## **ARCHITECTURAL ADVISORY COMMITTEE MEMORANDUM**

SUBJECT: BRIAN FOSTER FOR A MINOR ARCHITECTURAL APPLICATION FOR REVISIONS TO THE FRONT ENTRY AT OLD LAS PALMAS ESTATES SUBDIVISION TO INCLUDE NEW LANDSCAPING, GATE, AND SIGNAGE, LOCATED AT LAS PALMAS ESTATES DRIVE, ZONE R-1-B. (CASE 3.4194 MAA) (GM)

Existing - Modify to be  
Smooth Stucco Painted Dunn Edwards  
Warm White DEW380

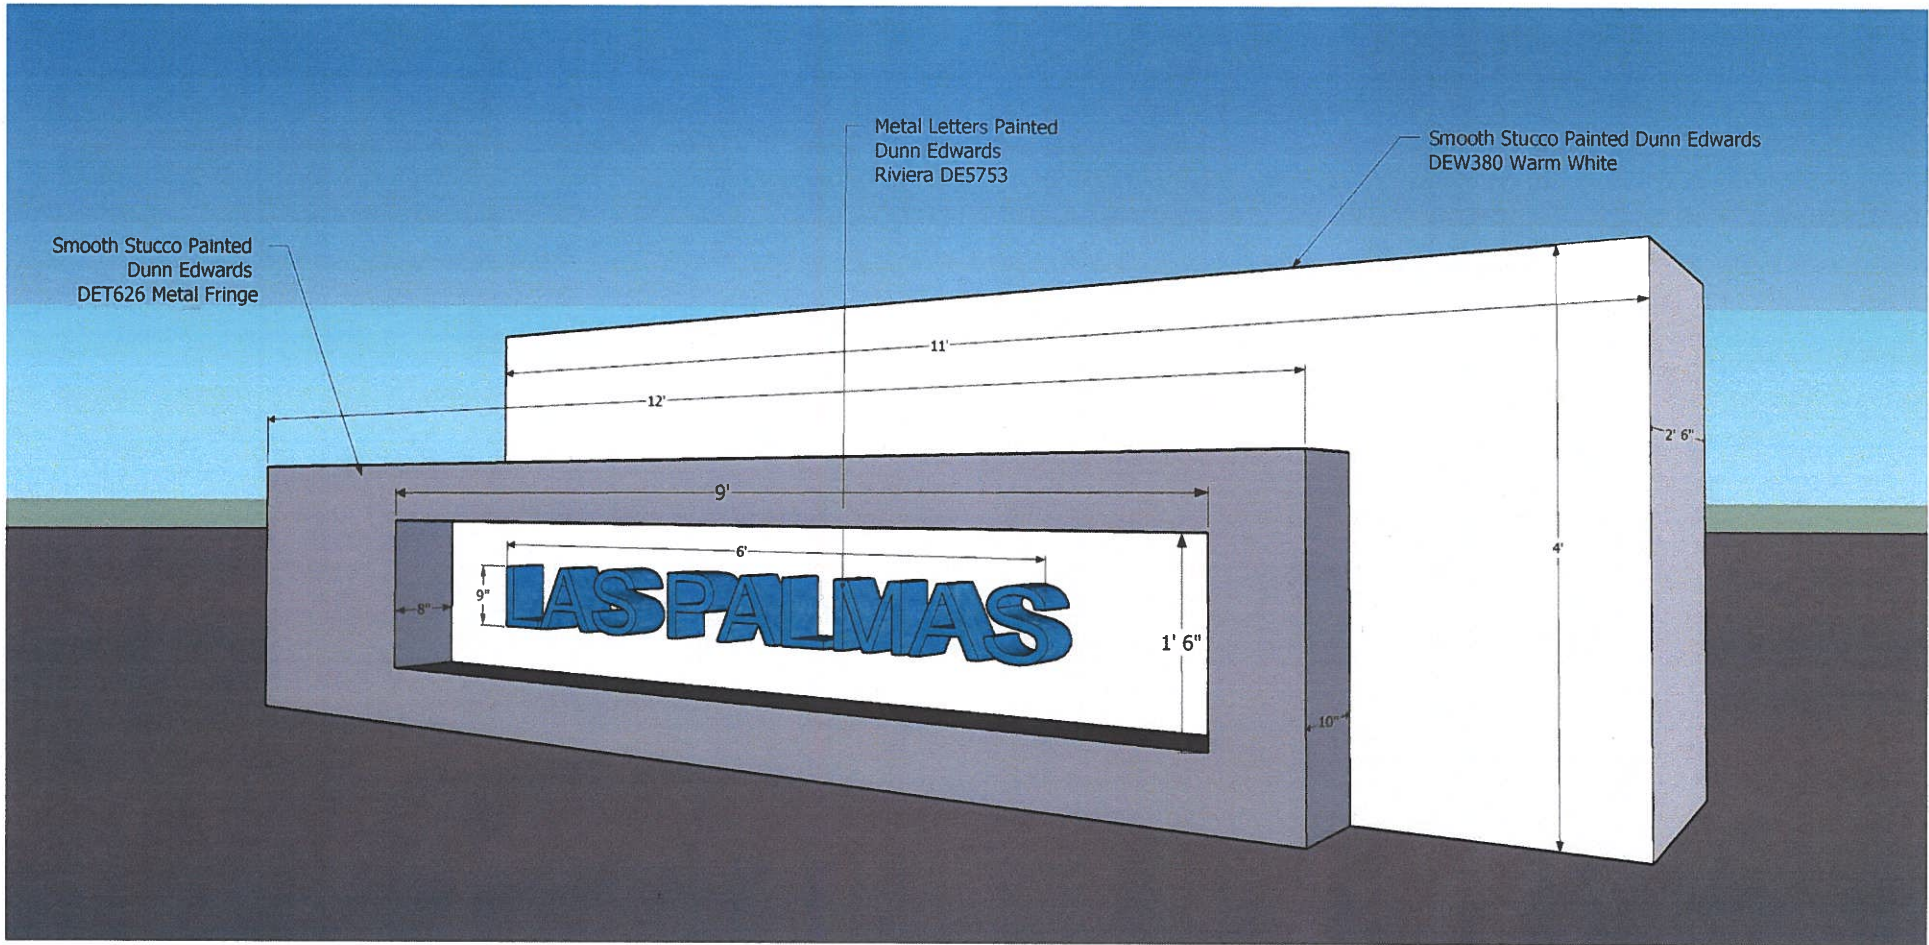
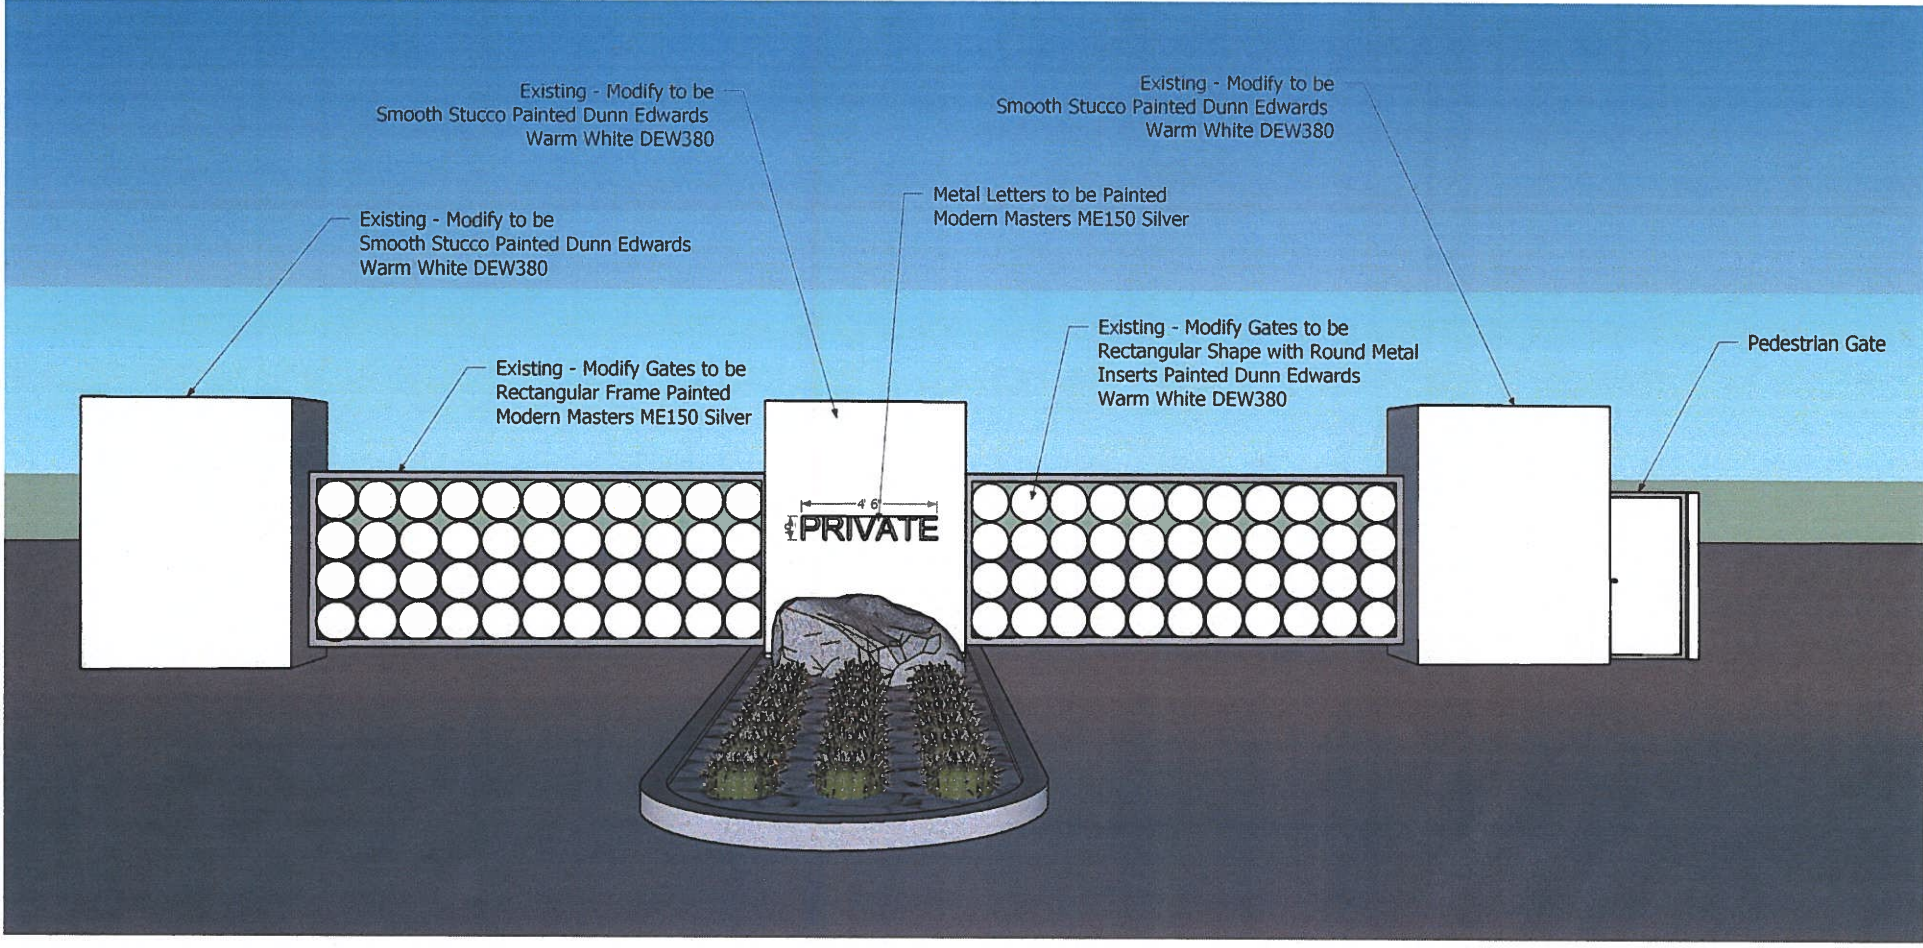
1. Add a pedestrian gate.
2. Lower the pillars to 12 feet.
3. Eliminate one monument sign.
4. Keep the existing berms.
5. Retain existing mature trees and boulders.
6. Consider using real turf instead of artificial turf.

1. Added a pedestrian gate on the right side of the vehicular gate.
2. Lowered the entry pillars from 14' to 12' feet.
3. One monument sign to be placed right of the entrance.

4. Existing landscaping to include berms, trees and boulders to remain.
6. The applicant prefers to use artificial turf, however is open to use real grass.
